## PRODUCT CHANGE NOTICE

**PCN/EOL#22-052**

<b>Existing P/N:</b>	<b>Replacement P/N:</b>
MAV-11SM+	<a href="#"><u>MAV-11BSM+</u></a>

**AN-60-059**

MAV-11BSM+

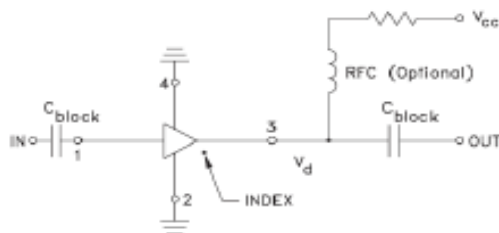
- 1) **FORM-FIT-FUNCTIONAL COMPATIBLE:** Same Circuit and PCB Layout and external components
- 2) Typical Performance Comparison <sub>a,b</sub>:

### COMPARISON PERFORMANCE CURVES:

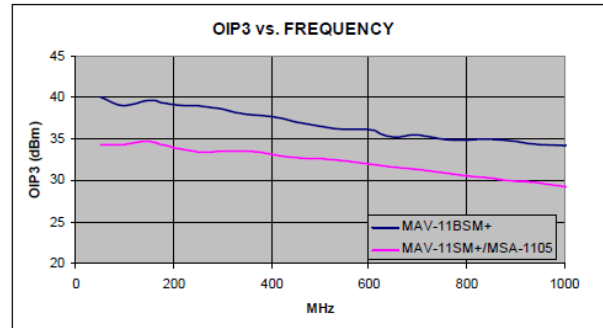
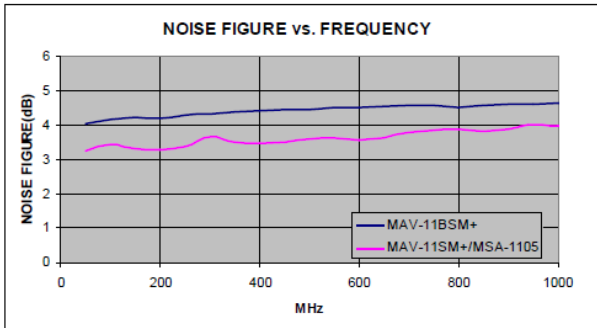
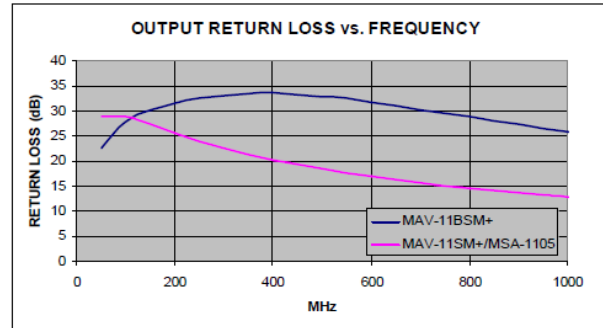
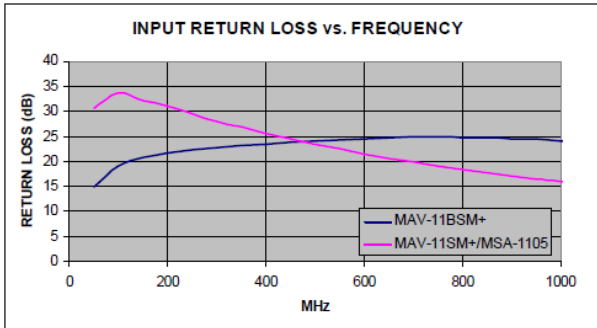
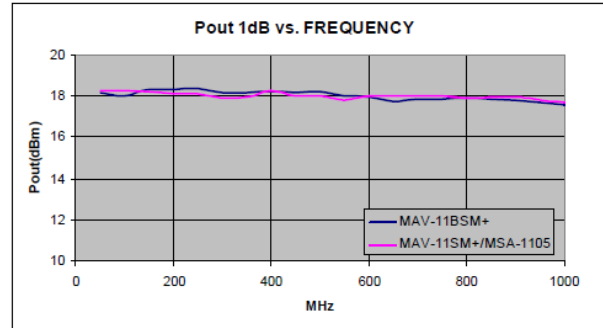
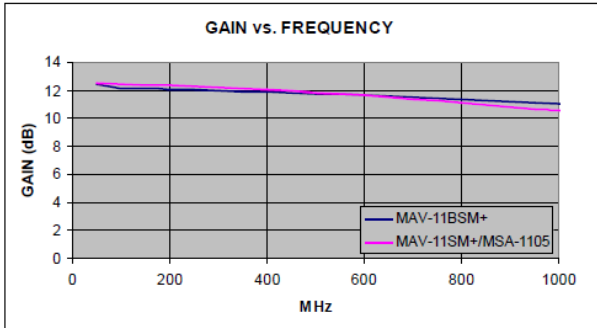
Performance	Condition(GHz)	MAV-11SM+/MSA-1105	MAV-11BSM+
Gain (dB)	1.0	10.5	11.3
Noise Figure (dB)	0.5	3.6	4.4
Pout 1dB (dBm)	0.5	17.5	18.2
Output IP3 (dBm)	0.5	+30	+36.5
Input Return Loss (dB)	0.05-1	14	14-24
Output Return Loss (dB)	0.05-1	11.5	22
Operating Voltage (V)	---	See table above	See table above
Operating Current (mA)	---	60	60
Status	---	Qualified, last time buy	Qualified, in production
